# UNITED STATES PATENT AND TRADEMARK OFFICE

APPLICATION NO.	FILING DATE	FIRST NAMED INVENTOR	ATTORNEY DOCKET NO.	CONFIRMATION NO.
10/600,169	06/19/2003	Dong Pil Park	DAE-0007	7167

# Office Action Summary

## DETAILED ACTION

*FIG. 7*

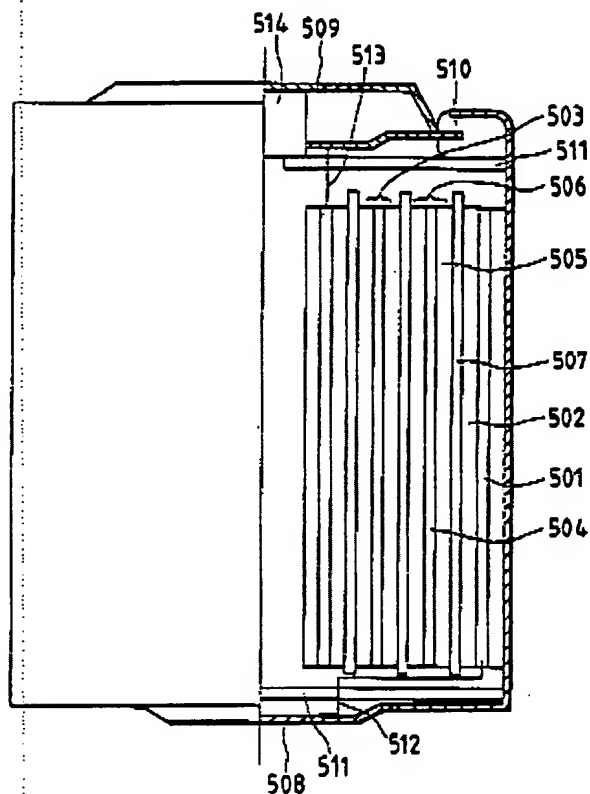
With respect to claim 6, Kawakami teach a method for manufacturing a powdery material electrode member for a secondary cell wherein the hydrogen-storing compound powder obtained in Example 4 was mixed with 2 weight ratio of flake-like nickel coated graphite powder, 85 um in average particle size, 1 weight ratio of spherical nickel powder, 10 um in average particle size as the auxiliary conductive materials, and 3% by weight of polyvinyl alcohol on the compound powder basis under the addition of water to prepare a pasty mixture and the mixture was filled in a spongy nickel porous member "current collector" having a porosity of 95% and an average pore size of 150 um. After drying, the filled member was pressurized by using a roller press and cut to a predetermined size. To the cut member, a nickel lead wire was connected and an electrode member serving as the negative electrode of a secondary cell was obtained (Col 27 lines 55-67). In FIGS. 6, 7 and 8, Numerals **401**, **503** and **601** denote negative electrodes comprising a negative electrode active material layer. Numerals **501** and **600** denote negative electrode collectors (Col 21 lines 14-67). In Fig. 7 the negative electrodes **503** which comprise nickel strips are facing each other.

With respect to claim 8, Kawakami teach a that the negative electrode **503** is connected via a negative electrode lead wire **512** to the negative electrode can **508**, whereas the positive electrode **506** is connected via a positive electrode lead wire **513** to the positive electrode cap **509** (Col 21 lines 14-67) (See Fig. 7). Fig. 7 shows that the leads are connected at the upper and lower edges of the collectors.

With respect to claim 11, Kawakami teach a that the negative electrode **503** is connected via a negative electrode lead wire **512** to the negative electrode can **508**, whereas the positive electrode **506** is connected via a positive electrode lead wire **513** to the positive electrode cap **509** (Col 21 lines 14-67) (See Fig. 7). Fig. 7 shows that the negative electrodes **503** face each other. Regarding metal hydride contained

With respect to claim 15, Kawakami teach a that the negative electrode **503** is connected via a negative electrode lead wire **512** to the negative electrode can **508**, whereas the positive electrode **506** is connected via a positive electrode lead wire **513** to the positive electrode cap **509** (Col 21 lines 14-67) (See Fig. 7). Fig. 7 shows that the leads are connected at the upper and lower edges of the collectors.
